Application of Cultivate Communities c/o Battle Law, P.C. to rezone property from the R-100 (Residential Medium Lot-100) zoning district to the RSM (Small Lot Residential Mix) zoning district to allow a residential development.

PETITION NO: N5-2026-1264 Z-26-1248278

STAFF ANALYSIS

LAND DEVELOPMENT ANALYSIS

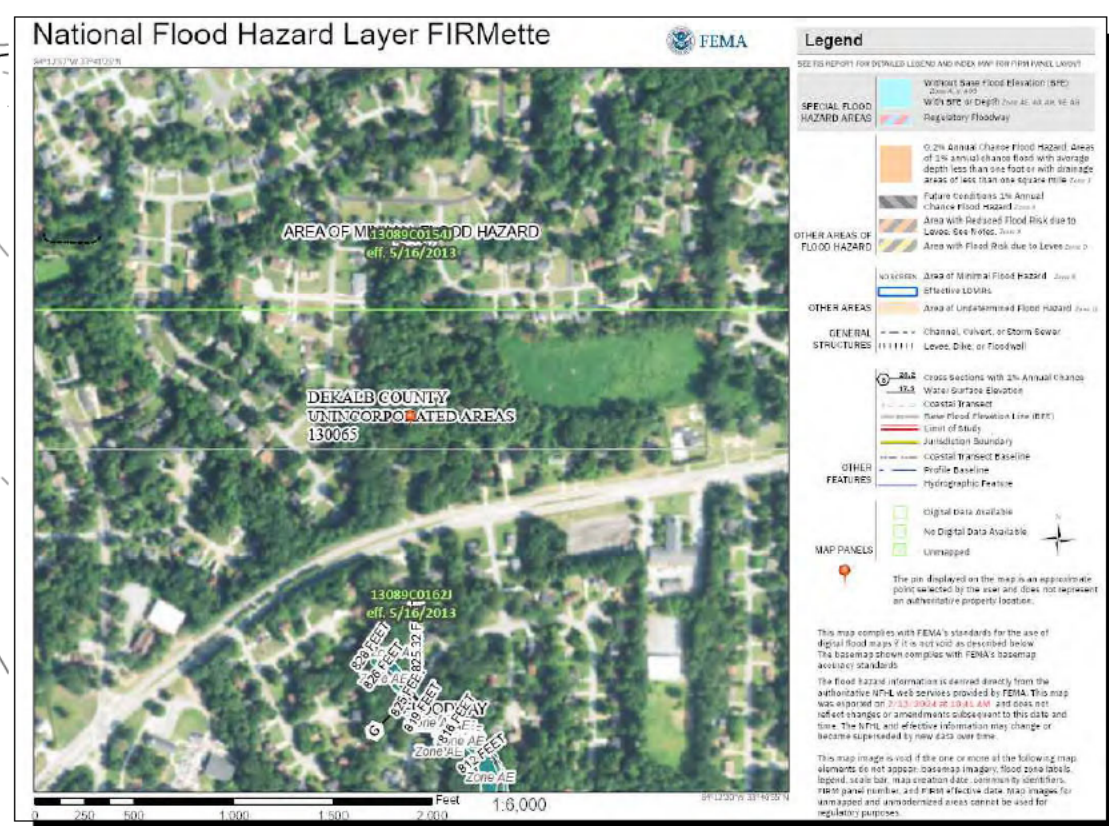
Comments: Must show compliance with RSM zoning standards and show how property is

consistent with surrounding single-family uses and the SUB CHAracter area. Max density is 8 units per

acre with density bonuses.
